CALIFORNIA COASTAL COMMISSION

REGULAR CALENDAR
STAFF REPORT AND PRELIMINARY RECOMMENDATION

Application No.: 6-03-41

Description: Demolish and remove damaged paving, railing, kiosk and underground utilities. Also proposed is removal of all riprap from the beach and installation of a sheetpile wall (with toe-stone) on the north end of the site and a sheetpile/shotcrete seawall on the south end of the site, both of which will connect to an existing sheetpile wall located in the center of the site. In addition, the project includes a request for after-the-fact approval of the existing 540 ft. long sheetpile seawall. Construction also includes the relocation of the existing park entryway from Highway 101, grading and parking lot improvements resulting in the loss of approximately 108 parking spaces.

**Proposed Northern
Sheetpile Wall and
Improvements**

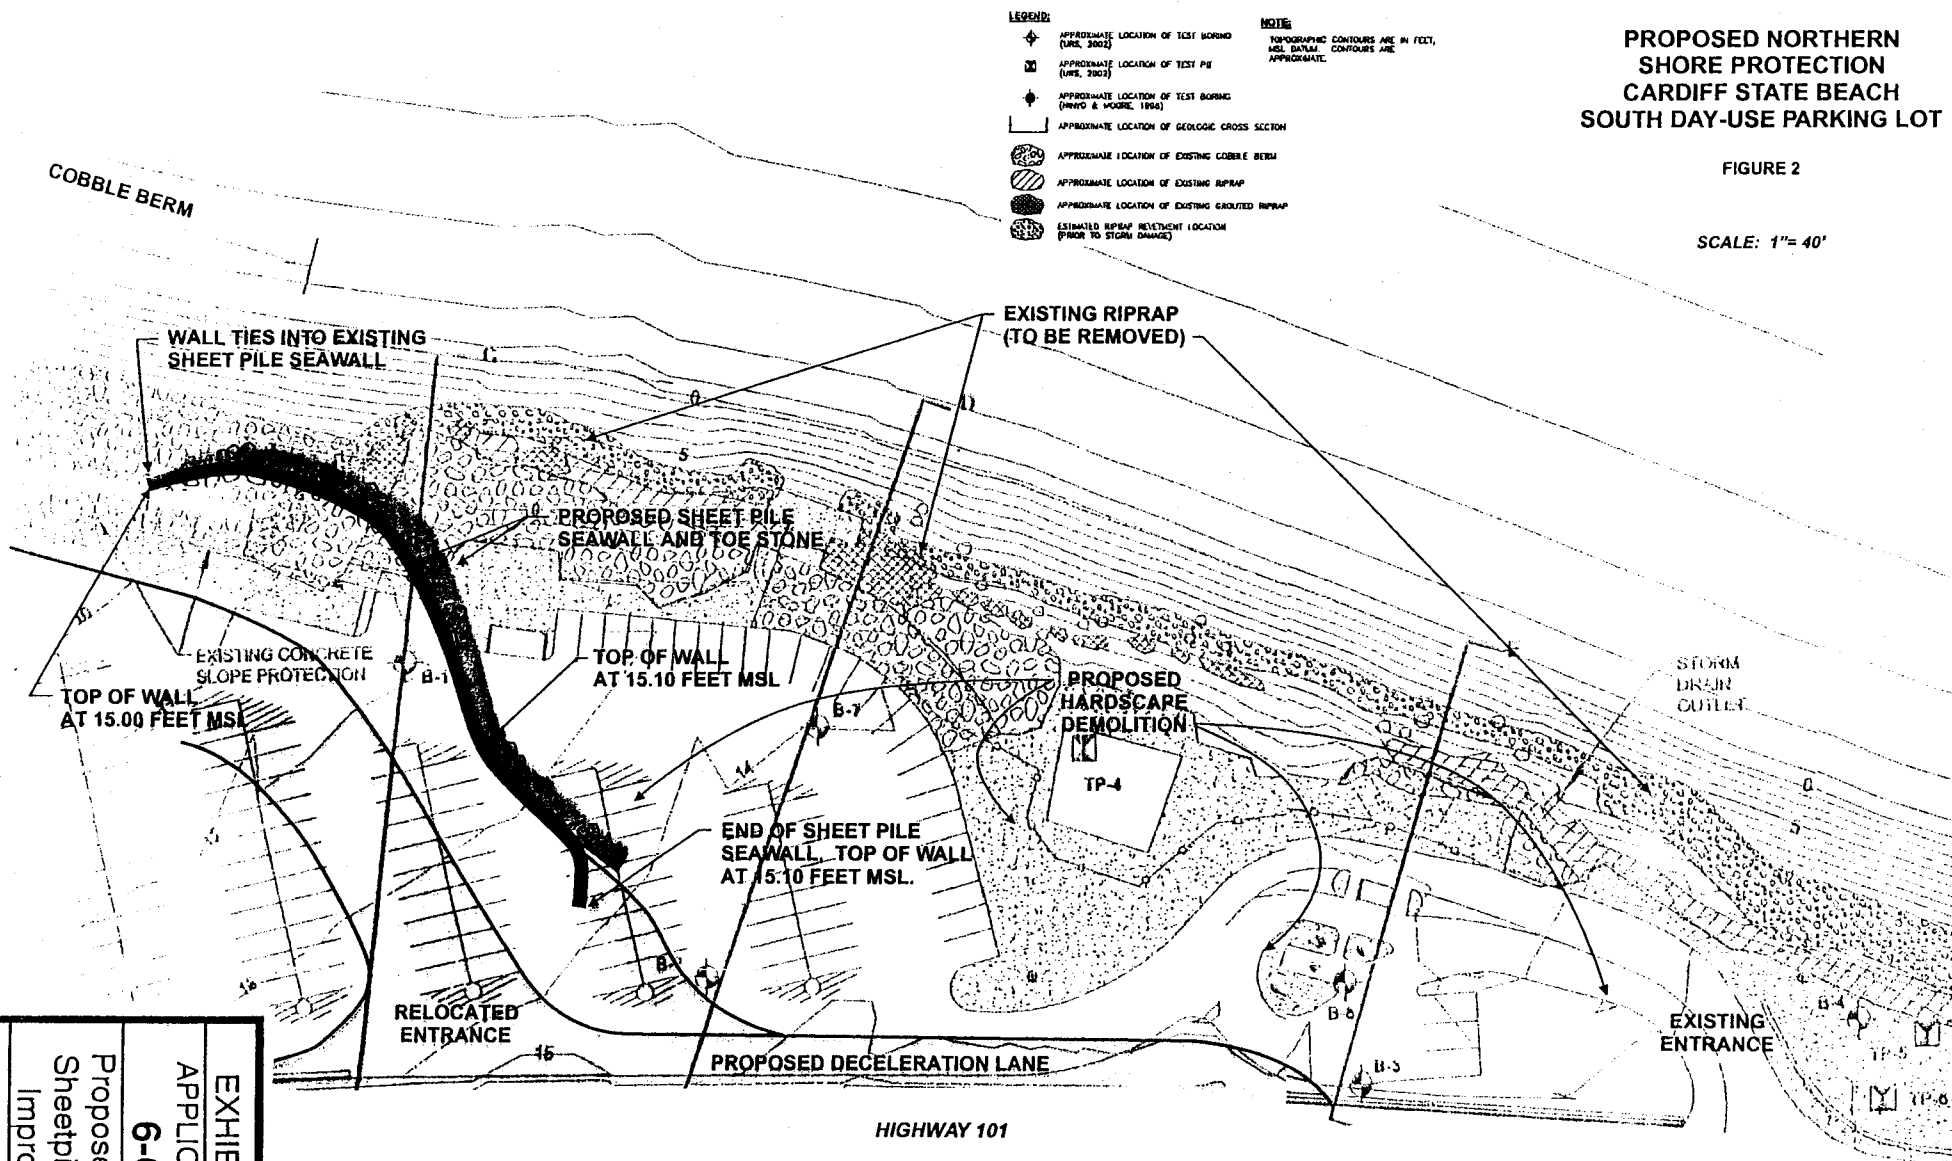
- b. All visible and extractable riprap from the dry beach area along the northern section of the park facilities commencing seaward of the northern end of the existing sheetpile wall to approximately the location of the current entry road shall be removed from the beach, excluding rock approved for use as toestone for the new northern sheetpile wall. This area would span approximately 575' shore parallel, from the southernmost portion of the proposed new northern sheetpile wall and the new entry road, to a northern location approximately 40 feet south of the southernmost extent of the proposed bus pad (consistent with the location of existing riprap depicted on attached Exhibit #4). The approved toestone for the new northern sheetpile seawall is restricted to a zone within 12' of the new northern sheetpile seawall, with a top elevation of +3' MSL.

Proposed Southern
Sheetpile Wall -
Access Ramp
Improvements

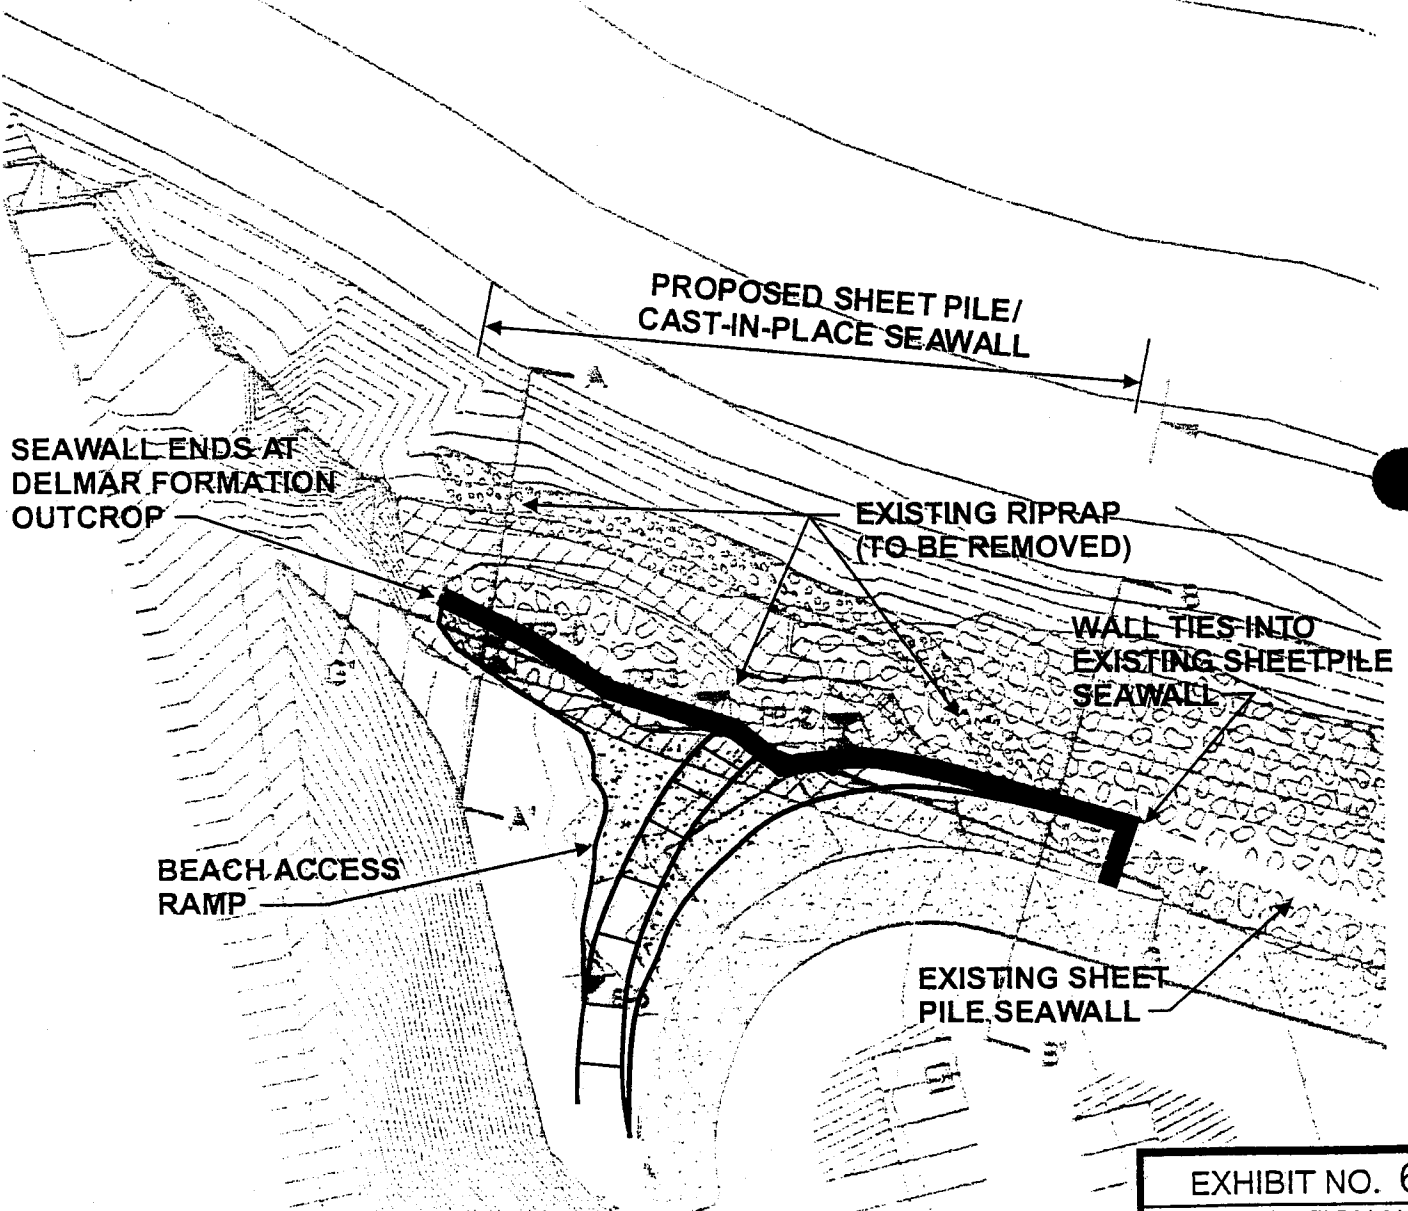
- a. The southern sheetpile wall and concrete seawall shall be sited and designed so as to more closely follow the natural contours of the adjacent bluff without extending into or affecting the existing footpath that extends from the southwest corner of the parking lot across the lower bluff to the beach area of Solana Beach.
- b. Except for the rock necessary to be used for toestone for the northern extension of the sheetpile wall, all rock riprap proposed by the applicant to be removed (as depicted on attached Exhibits Nos. 4 and 6) north, south and seaward of the existing sheetpile wall shall be removed from the project site to the maximum extent possible (See Special Condition #2).
- c. The northern concrete seawall above the proposed approximately 237 ft.-long northern sheetpile wall shall be designed to be visually treated to maximum

- a. All visible and extractable riprap along the southern section of the park facilities (where there will be a new concrete and sheetpile seawall) shall be removed from the beach down to an elevation of -2 MSL, within the identified work area, and from the dry beach seaward of the work area. The removal area shall be the dry beach seaward of the new concrete or sheetpile seawall, noted on the construction plans as starting at Station 10+00.00 and terminating approximately 170' shore parallel, to the south, at the southernmost intersection of the new concrete wall with the Del Mar Formation (consistent with the location of existing riprap depicted on attached Exhibit #6).
